BUILDINGS 5 & 6 RENOVATIONS

CAÑADA COLLEGE
4200 Farm Hill Boulevard
Redwood City, CA 94061

THIRD FLOOR PLAN

Drawing Number: **A2.3**

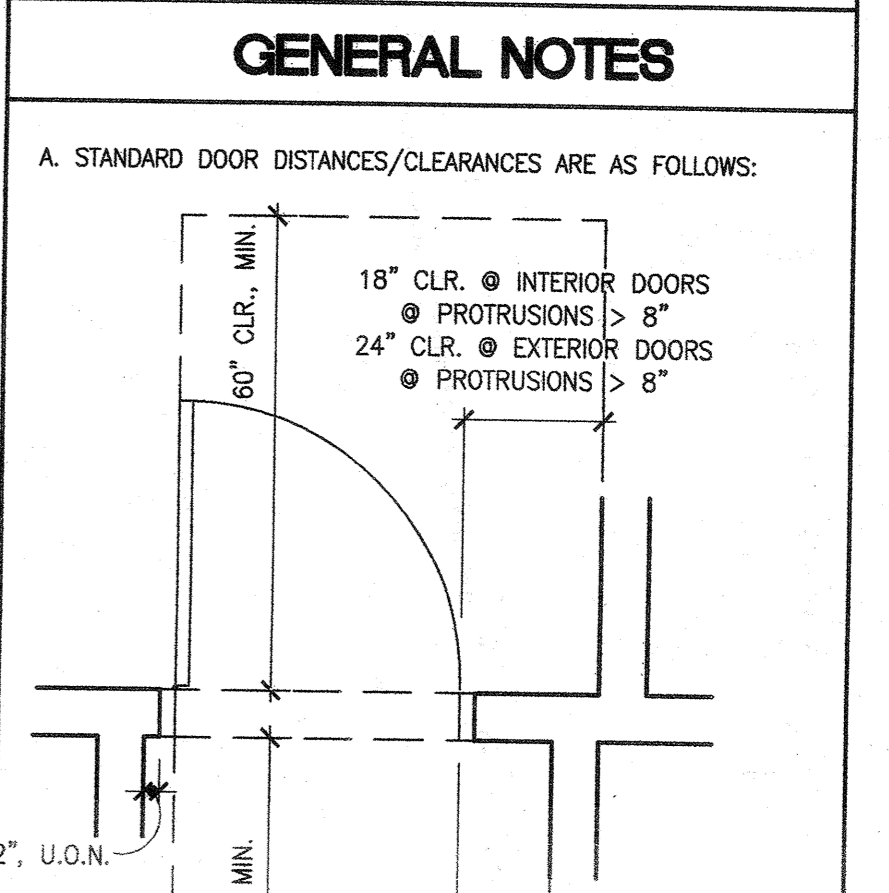
SEE RFI-25
EXISTING DOORS

SEE RFI-15 AND 23 STOREFRONT ANCHOR
